### HENDERSON COUNTY PLANNING BOARD

**SUBJECT:** Combined Master and Development Plan for Adger Oak

**Henderson County Planning Department Staff Report****Combined Master and Development Plan Review for Adger Oak Major Subdivision (File #2007-M18)**

**Map A: CCP Future Land Use Map**

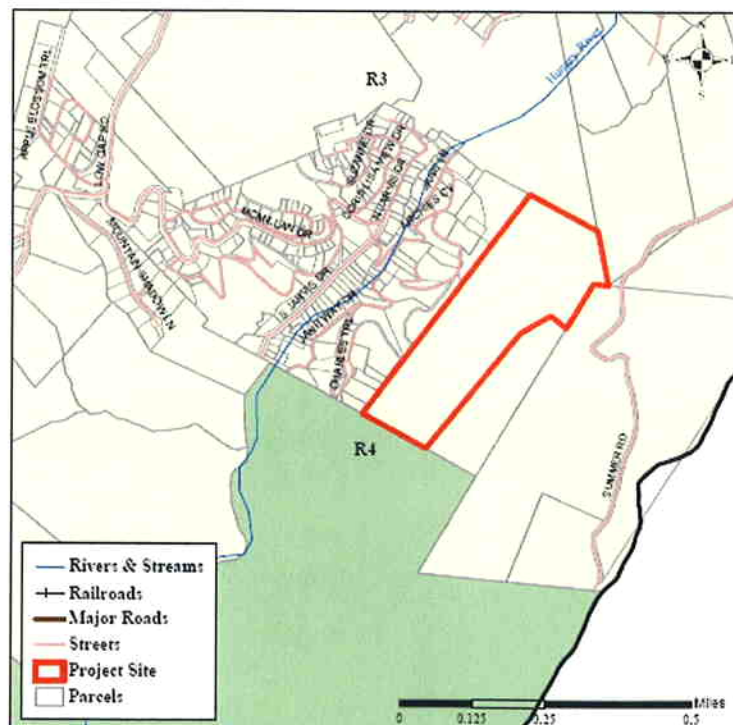
1. **County Comprehensive Plan (CCP).** The Future Land Use Map of the CCP shows the project site as being located within each of the following areas: Conservation Area and Rural Agricultural Area (RAA) (See Map A: CCP Future Land Use Map).

**Map B: Slopes Map**

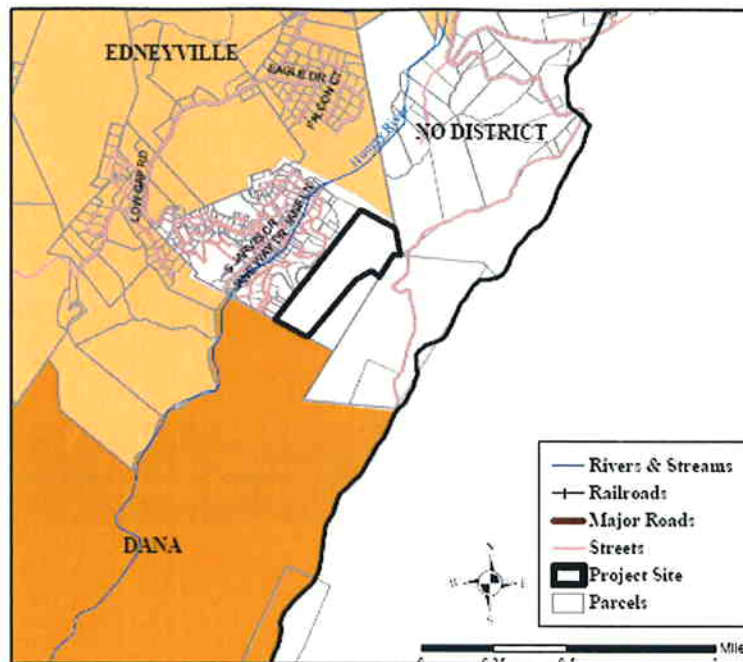
- Conservation Area.** The conservation area designation is applied to the western portion of the project site, largely because of the presence of steep slopes in this area (See Map B: Slopes Map). The CCP states that conservation lands “are intended to remain largely in their natural state, with only limited development,” and further that “such areas should be targeted for protection through regulations and incentives” (2020 CCP, Pg. 134). The plan suggests that those lands recommended for conservation will be primarily divided into Lots 4 through 38.

### ADDER OAK DEVELOPMENT COMBINED MASTER AND DEVELOPMENT PLAN

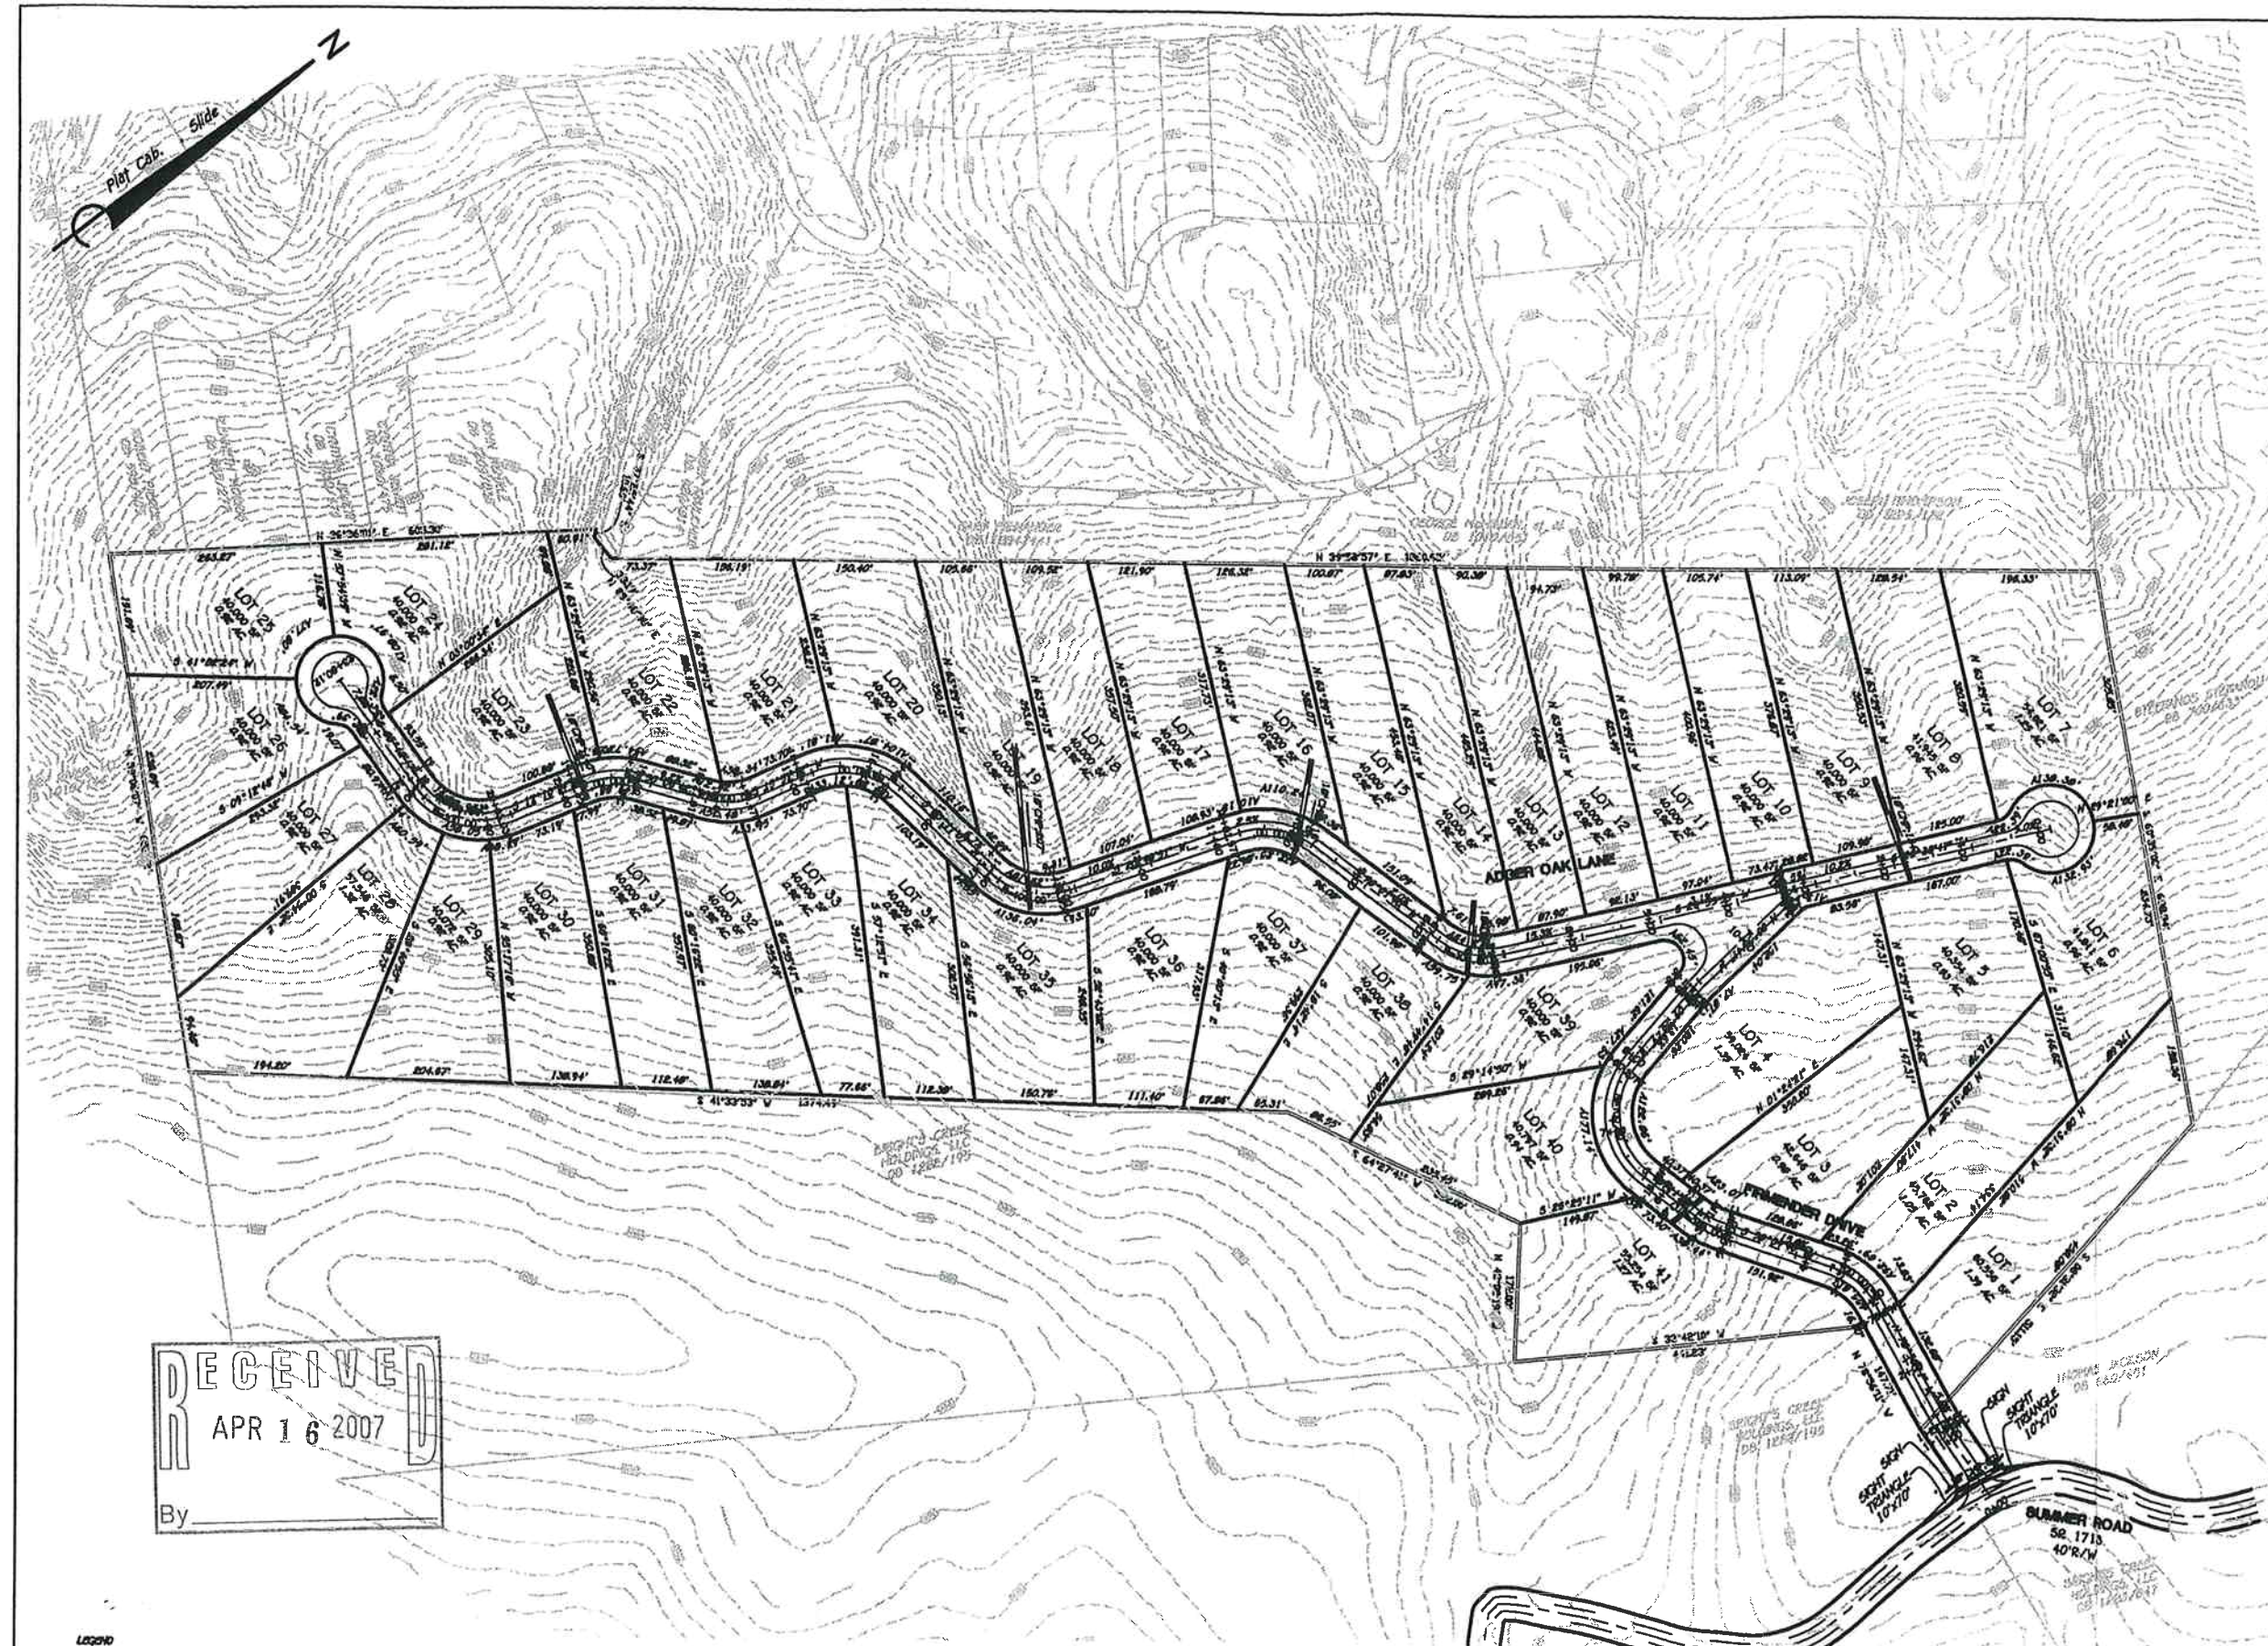
2. **Private Road Standards.** The Applicant has provided a cross section for the proposed roads (Firmender Drive and Adger Oak Lane). This cross section indicates that these are to be “local roads.” The cross section should be revised to indicate that these are to be “private residential collector roads” as these roads serve 25 or more lots. The proposed private road meets all other requirements for a collector road with the exception of the proposed centerline radii which must be 110 feet (the applicant has proposed 100 feet). All of the subdivision roads must be designed and constructed to the minimum standards of §170-21 of the HCSO (§170-21 and Table 1).

3. **Road Grade.** The Applicant has proposed a private paved road for the subdivision. The maximum road grade for private collector residential subdivision roads constructed of pavement is 16 percent. The plan shows road grades approaching 16 percent. A professional engineer or professional land surveyor must certify on the Final Plat that no portion of the road has a grade that exceeds 16 percent or submit a final as-built graded center line profile showing grade and alignment of the road (HCSO §§170-13A[5], 170-21 Table 1 and 170-21E).

4. **Road Intersection.** Design and subsequent construction of private roads shall be reviewed by the Planning Board based on the standards and requirements of NCDOT (HCSO §170-21(C)4). According to “Subdivision Roads Minimum Construction Standards” the most desirable intersections are those with angles of 75 to 90 degrees but that intersections with angles from 60 to 75 degrees are acceptable under extreme conditions. The Planning Board may wish to discuss with the applicant the intersection of

Firmender Drive and Adger Oak Lane. The intersection appears to have an internal angle of 30 degrees and an external angle of 150 degrees. Staff requests that the applicant provide a detail of the intersection. The Planning Board may wish to request that the applicant modify the intersection to be more in keeping with minimum construction standards.

5. **Drainage.** All road or drainage structures shall be constructed in accordance with state roads standards. Road drainage side ditches shall be constructed with sufficient depth and width to carry the expected volume of storm water runoff (HCSO § 170-21D). The applicant has proposed drainage onto Lots 8, 9, 16, 19, 23, and 41. Drainage easements shall be reserved on-site by the applicant, or otherwise provided, conforming with the lines of any drainageway into which natural runoff has been diverted (HCSO §170-29(C)).

7. **Subdivision Name Signs.** All major subdivisions may provide for, at the primary entrance, subdivision name signs to conform with Henderson County sign standards. The signs should be located in dedicated sign easements to be shown on the final plat (HCSO §170-24). The applicant is proposing two signs for the subdivision which do not appear to be located on the project site, and instead are located on properties owned by Bright's Creek Holdings, LLC. An easement must be acquired from the current property owner before any signs may be placed.

8. **Road Frontage and Existing Off-Site Access.** Any tract of land to be subdivided must have frontage on an existing public (state-maintained) road or a private right-of-way to the public road (HCSO §170-28). The plan shows a 50 foot right-of-way to the public road which traverses three separate properties and extends approximately 100 feet from the project site at the existing right-of-way for Summer Road. Henderson County records do not show the existence of any such right-of-way. As proposed the applicant does not have frontage or a private right-of-way to an public (state maintained) road. Such frontage or right-of-way must be acquired by the applicant in order to obtain development plan approval.
